## Product Change Notification / SYST-29WXAV969

ERRATA - dsPIC33FJ06GS101/X02 and dsPIC33FJ16GSX02/X04 Family Silicon Errata and Data Sheet Clarification Errata Document Revision

**Description of Change:** Added data sheet clarifications 3 (Pin Diagrams), 4 (Electrical Characteristics), 5 (Packaging Information) and 6 (Product Identification System).

## dsPIC33FJ06GS101/X02 and dsPIC33FJ16GSX02/X04 Family Silicon Errata and Data Sheet Clarification

**FIGURE 1: TIMING DIAGRAMS FOR CENTER-ALIGNED AND EDGE-ALIGNED MODES**

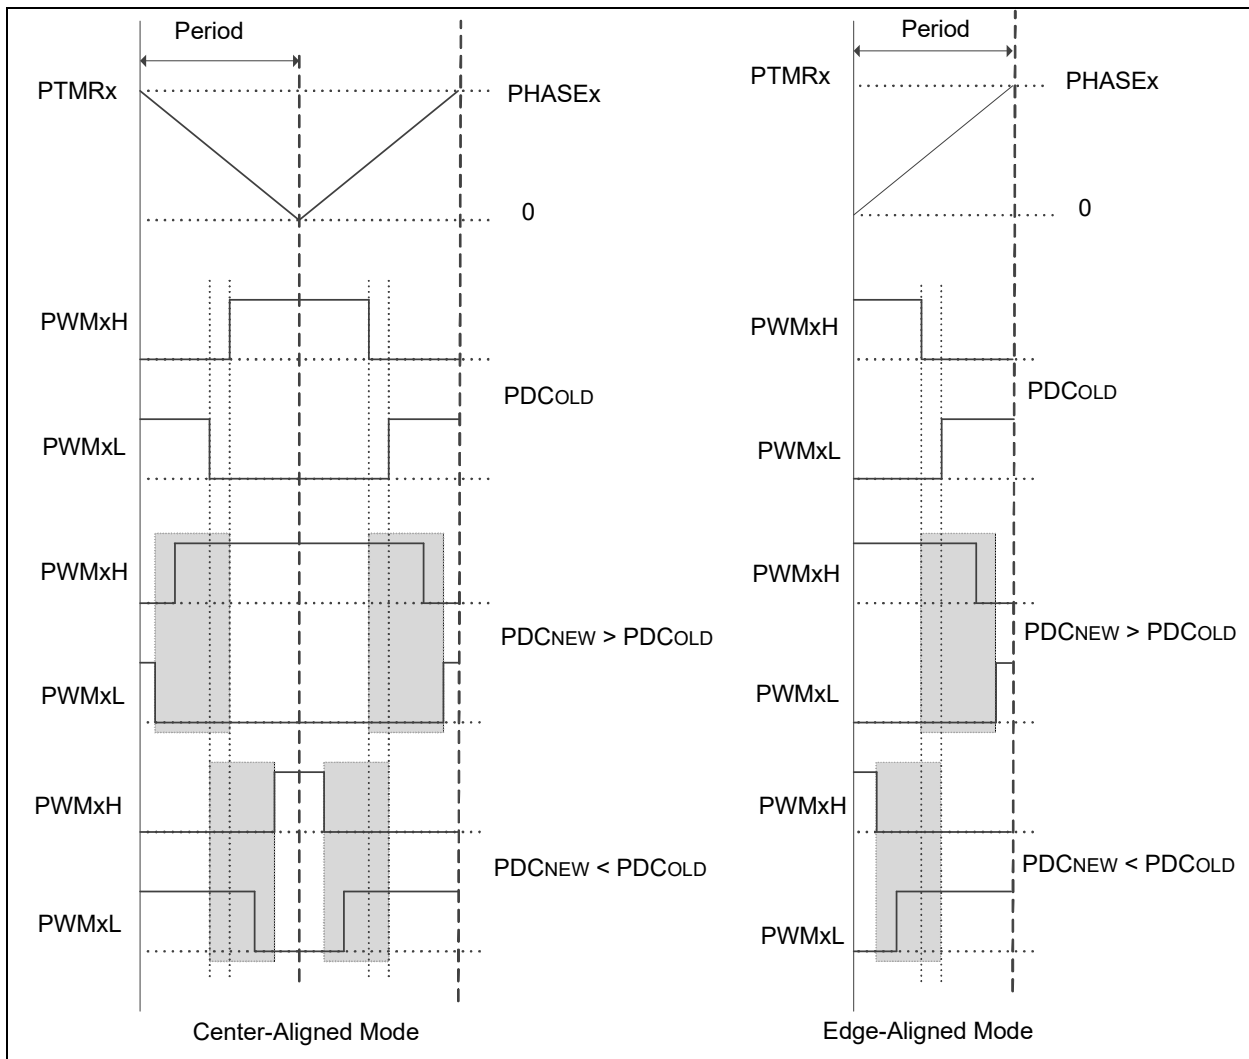
In [Figure 1](#) (following page), if the duty cycle write occurred in the shaded box, then PWMxH and PWMxL will make an immediate transition without dead time.

**FIGURE 2: ISSUE EXAMPLE FOR REDUNDANT OUTPUT MODE**

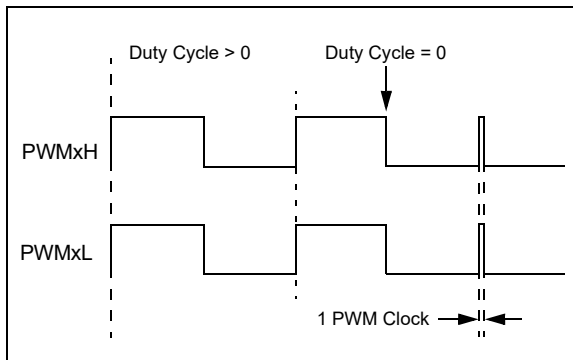
In Redundant Output mode (IOCONx[11:10] = 01) and Push-Pull Output mode (IOCONx[11:10] = 10), with the Immediate Update disabled (PWMCONx[0] = 0), when the Duty Cycle register is updated from a non-zero value to zero, a glitch pulse of a width equal to one PWM clock will appear at the next PWM period boundary, as shown in Figure 2 (for the Redundant Output mode). The Duty Cycle register refers to the PDCx register if PWMCONx[8] = 0 or the MDC register if PWMCONx[8] = 1.

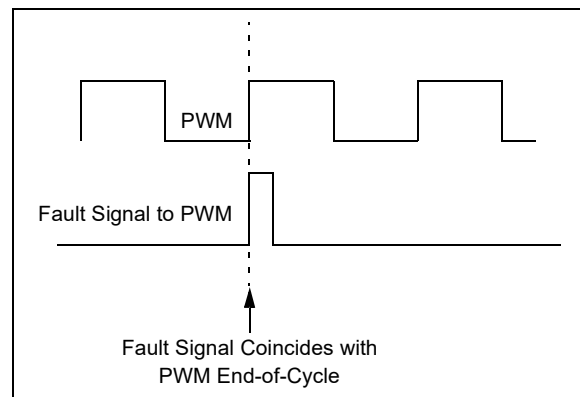
- When BRGH (UxMODE[3]) = 1, the Stop bit may be shortened by 1/4 of a bit clock
- When BRGH (UxMODE[3]) = 0, the Stop bit may be shortened by 1/16th of a bit clock

- Use the TXBF flag instead of the TRMT bit for loading new data into the TXREG
- Use FIFO mode instead of Buffer mode
